MEETING NOTICE – SITE REVIEW COMMITTEE

5. DISCUSSION AND ACTION - Request for a 224-unit, 16 building leased multi-family residence development with detached office building along S. Pine Tree Road (Portion of HB-350) (Page 4)

6. DISCUSSION AND ACTION - Request for an approximately 135-unit, 6 building leased mini-storage warehousing development to the rear of the property located at 3849 W. Mason Street (Page 49)

7. UPDATE AND ACTION - Request to modify previously approved site plan for self-storage units located at 3346 S. Pine Tree Road, decreasing the total number of units and overall buildings within the development (Page 57)

OVERALL SITE PLAN

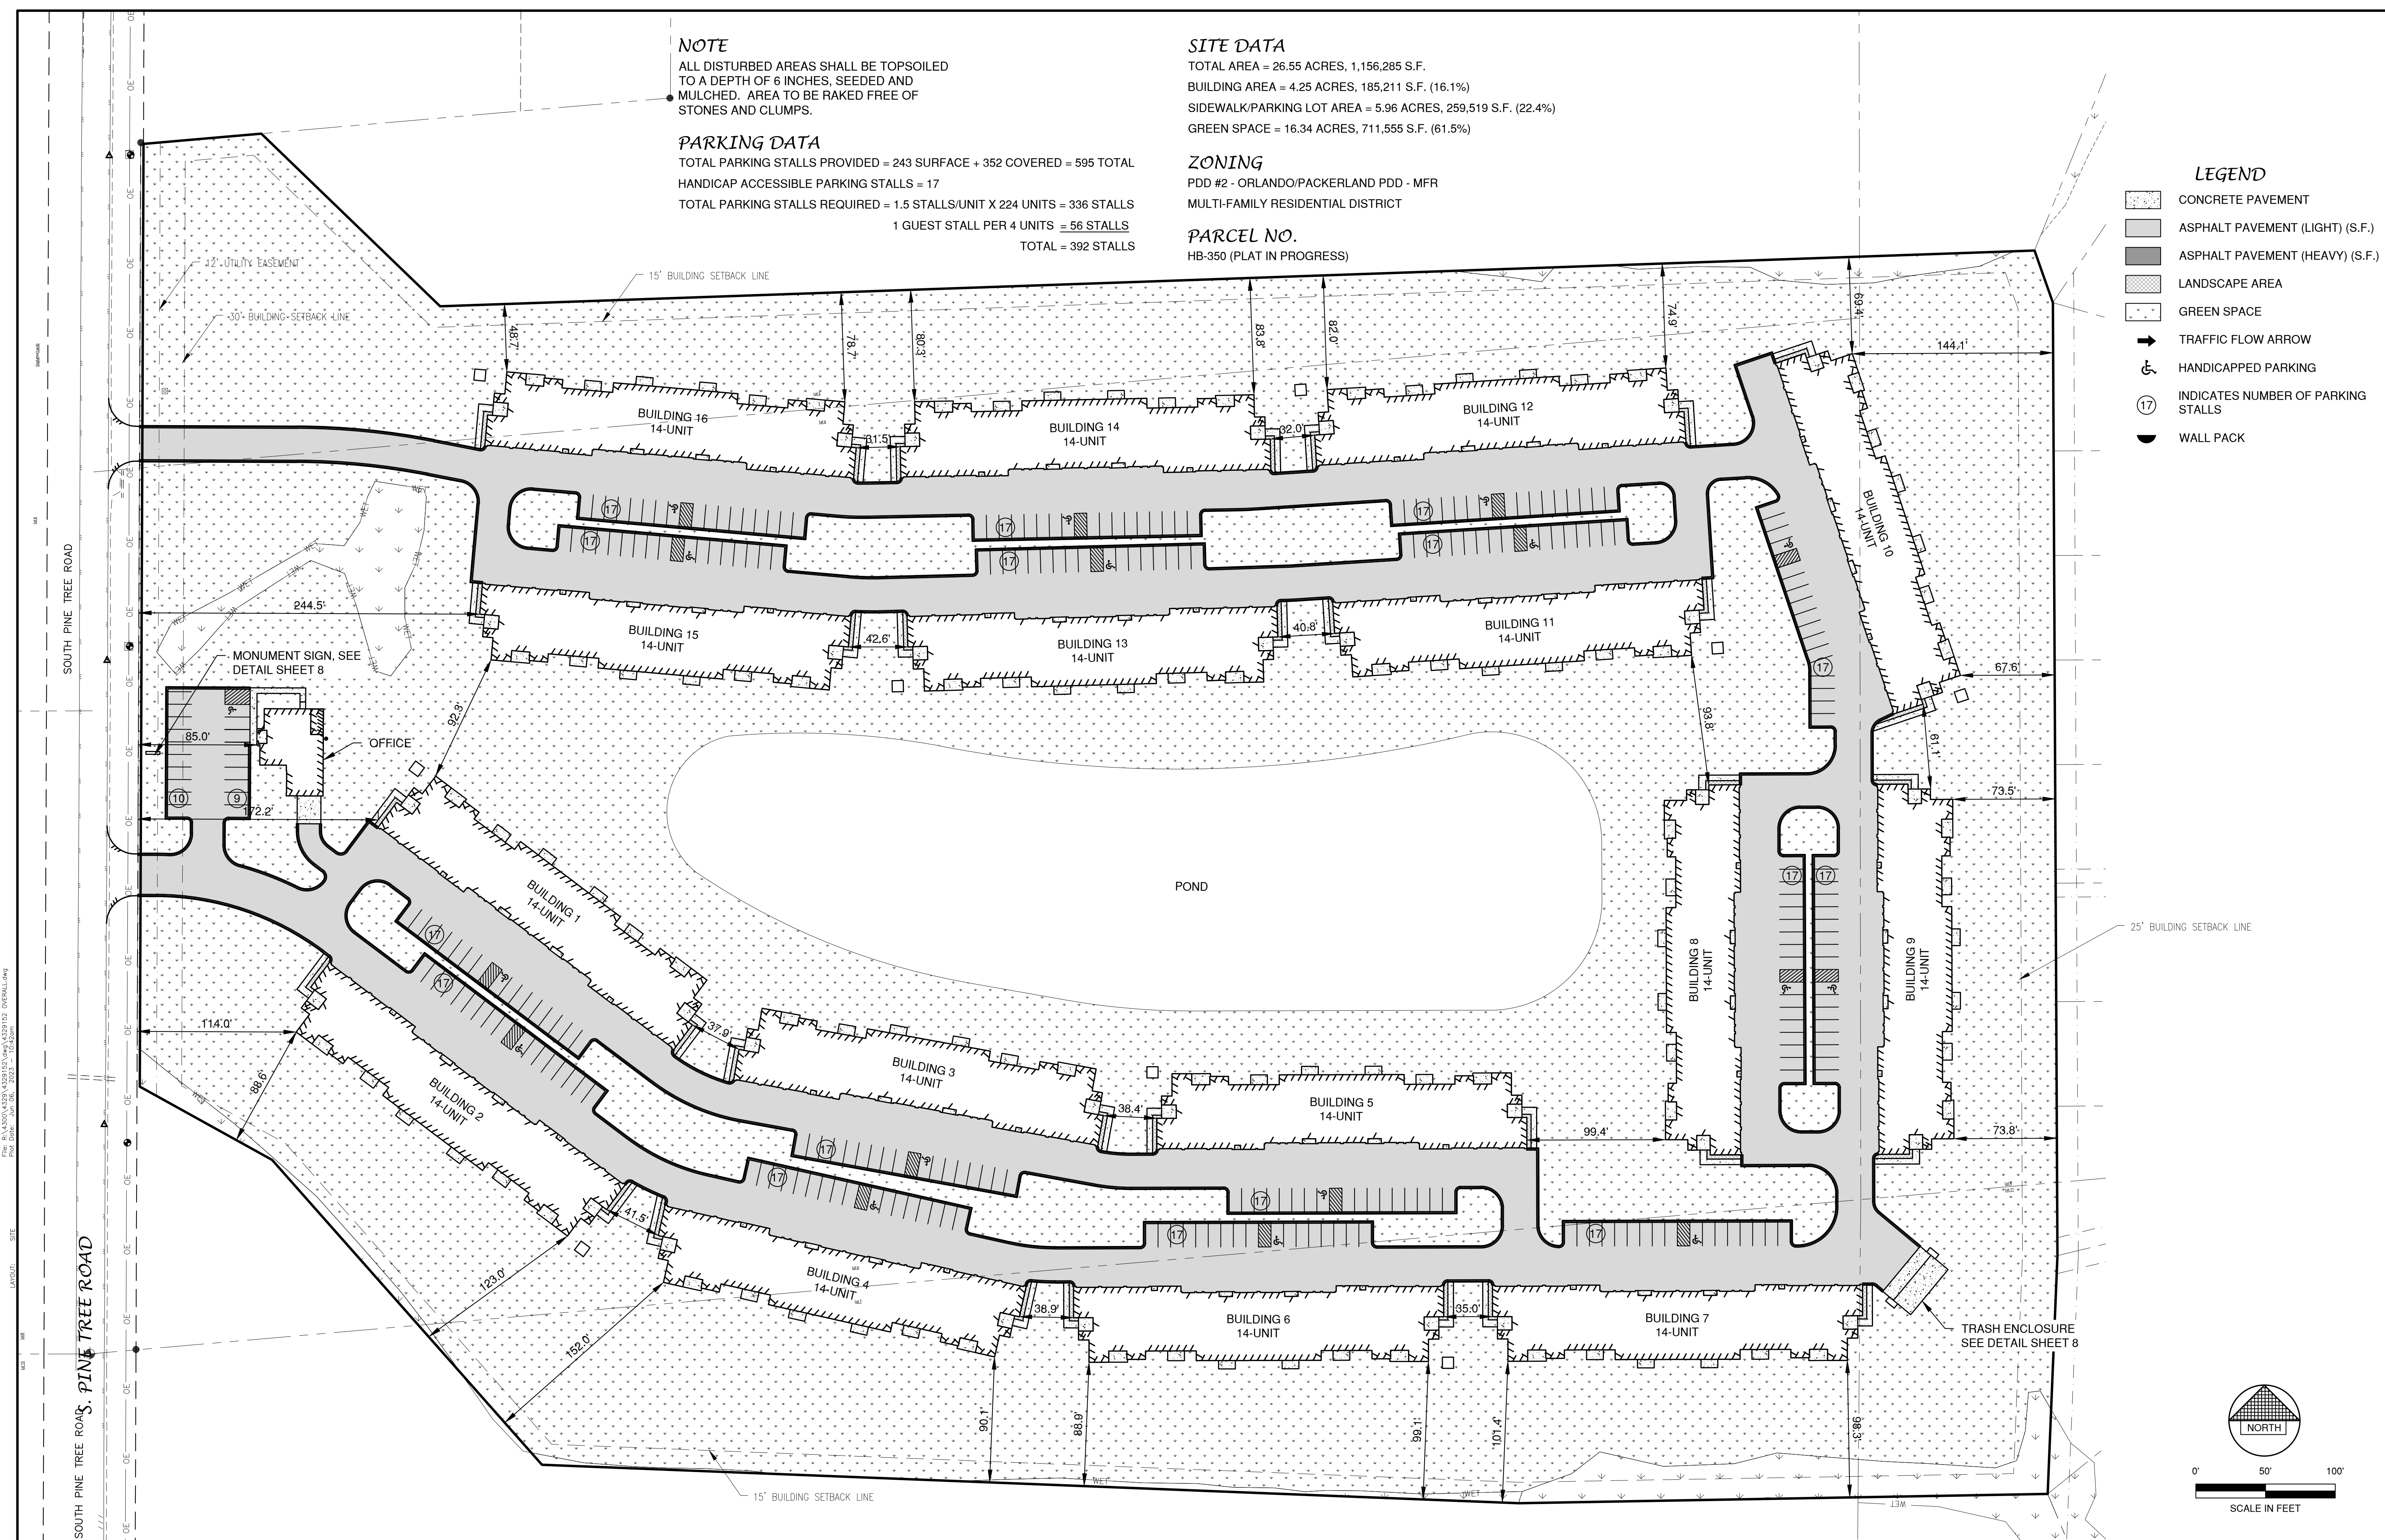
- A. Zoning:** PDD #2: Orlando/Packerland Planned Development District
- B. Green Space:** 61.5% green space, exceeding the 25% requirement (REL sheet 3)

- C. Setbacks:** Compliant with zoning district required setbacks (code/(proposed) – Front 30/(85), Side 15/(48.7), Rear 25/(67.6)) (REL sheet 3)
- D. Parking:** The requirements for multi-family developments are 1 and 1/2 stalls per unit plus one guest space provided for each four units and 50% of the required parking must be enclosed. Thus 336 parking stalls are required, with 168 of those being enclosed (garage stalls.) The development provides a total of 595 parking stalls with 352 of those stalls being enclosed/garage stalls. (REL sheet 3)

LANDSCAPE PLAN
 DATE: 05/2023
 FILE: LANDSCAPE
 JOB NO.: 4291152

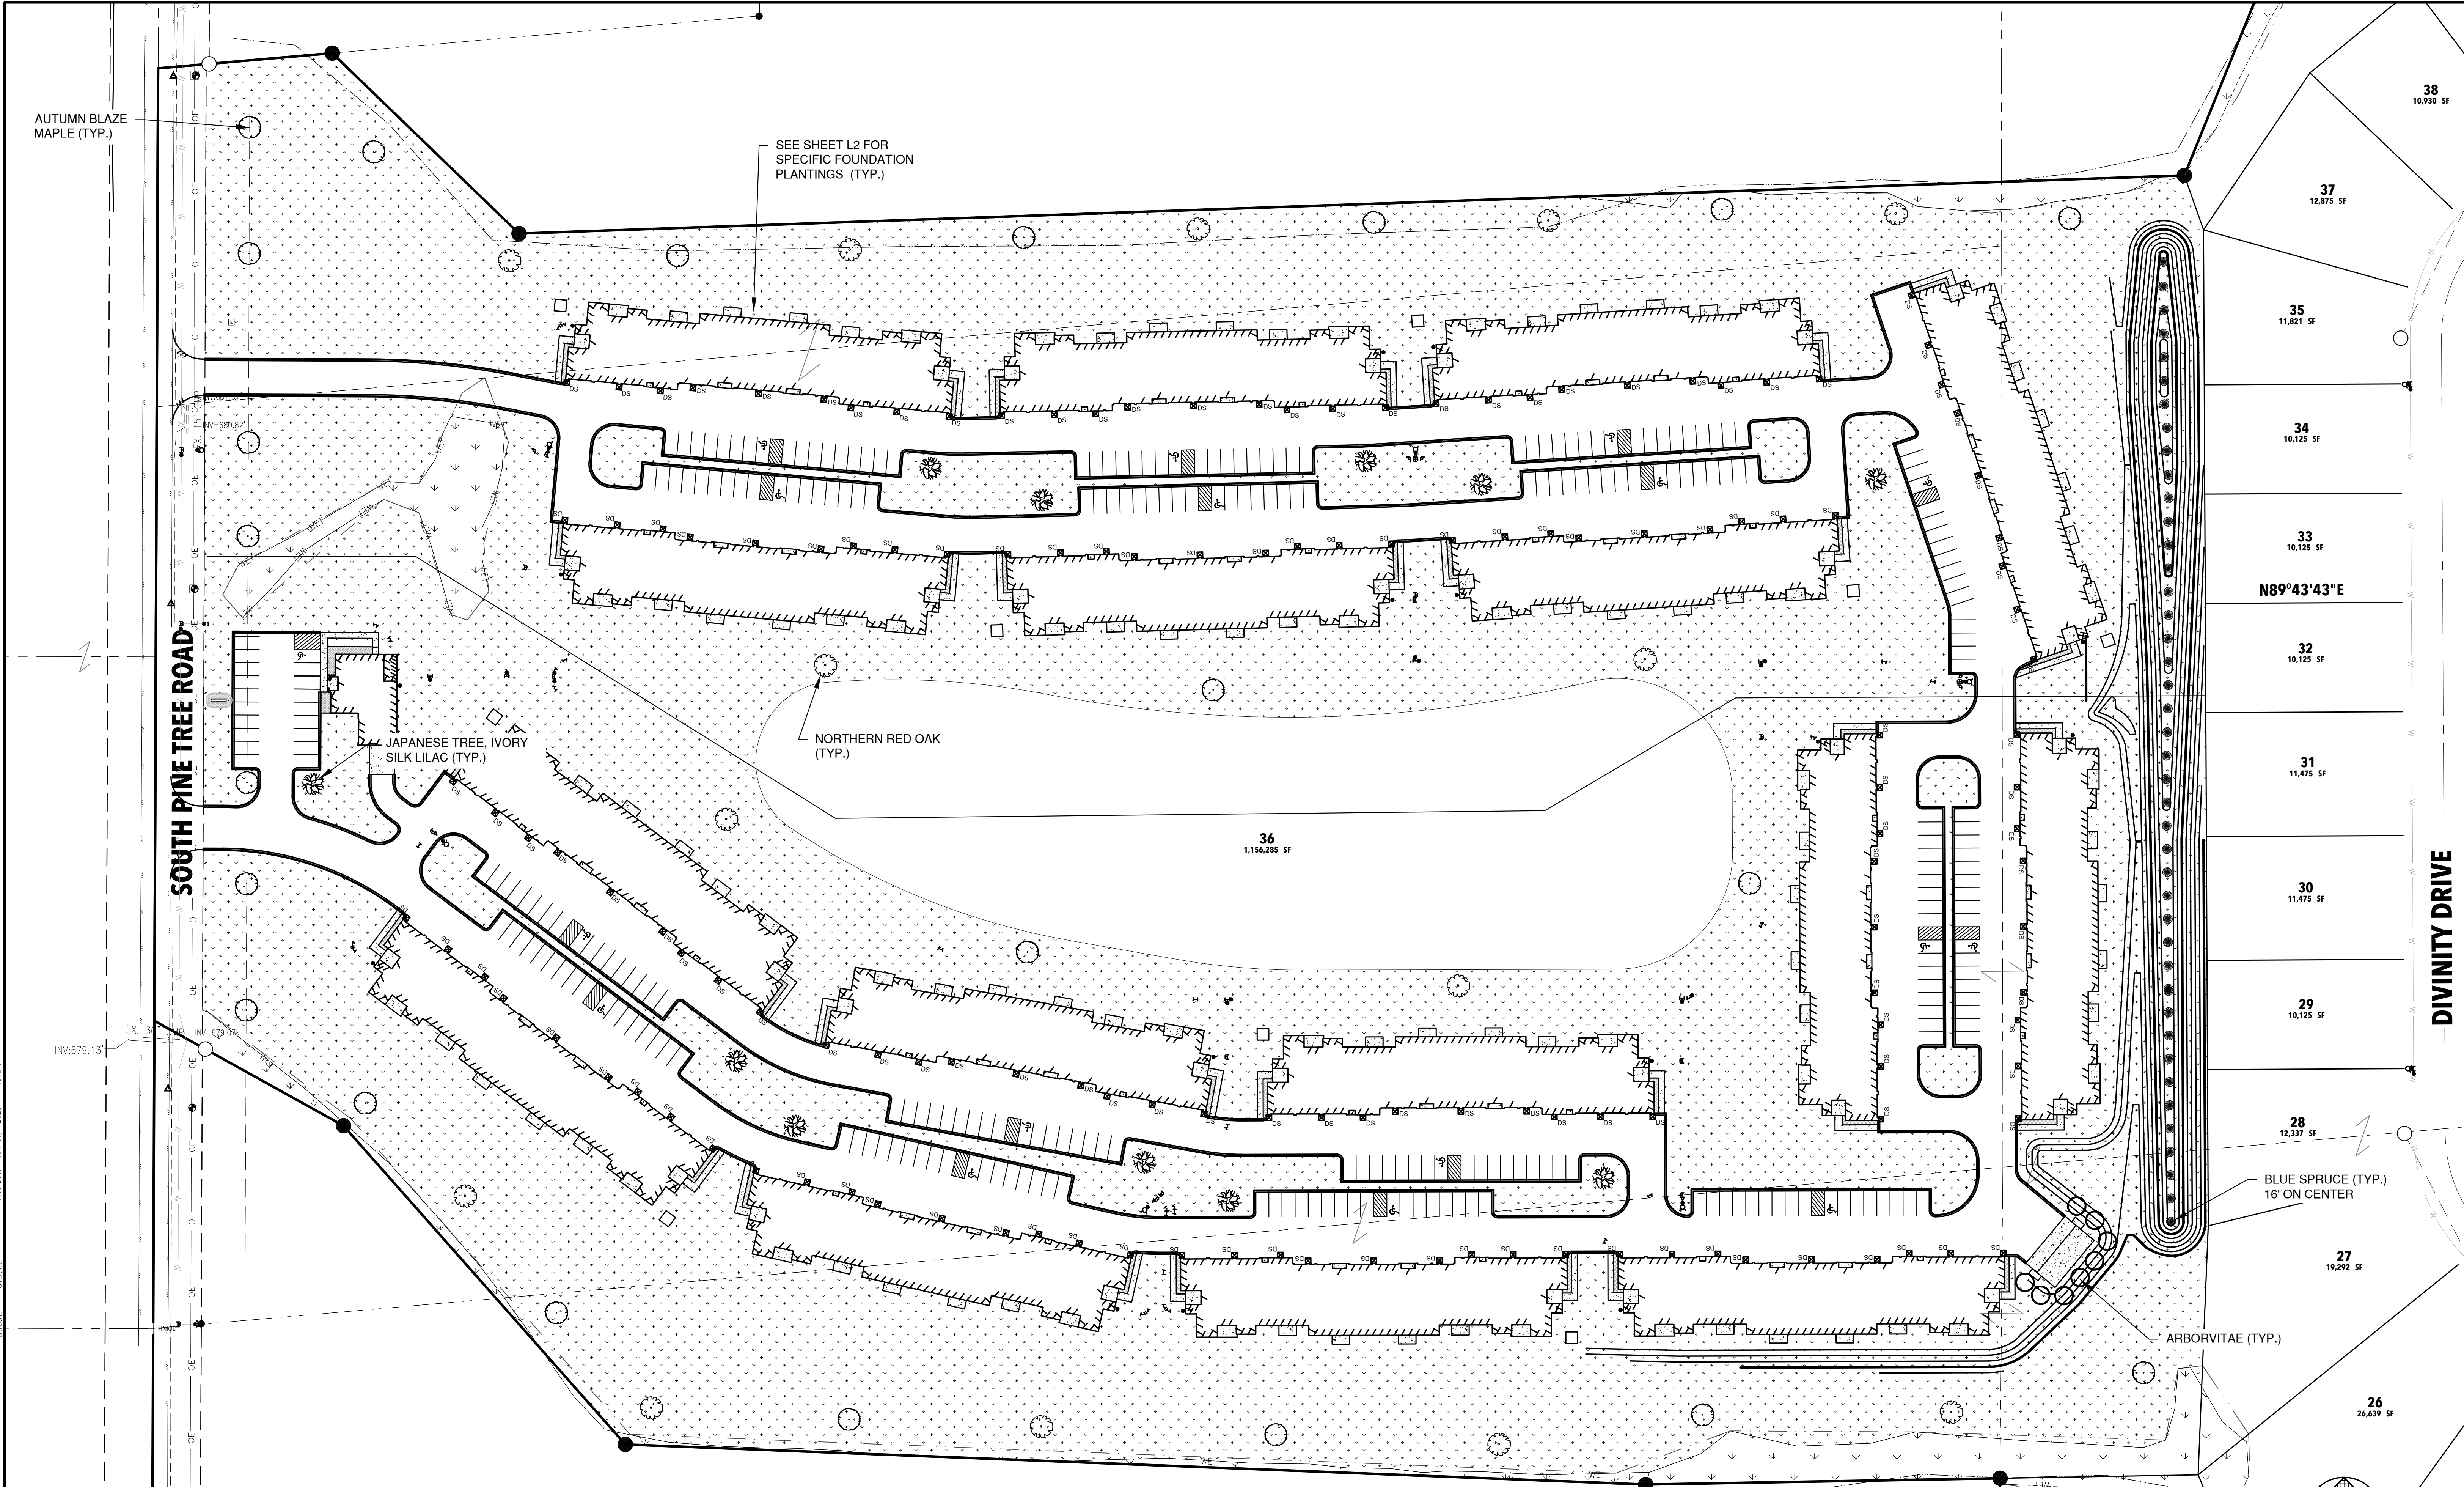
Section 5, Landscaping Plan: The landscape plan is compliant with village ordinances and there is a landscape berm proposed along the rear of the development which will be abutting the soon to be constructed single-family residential dwellings.
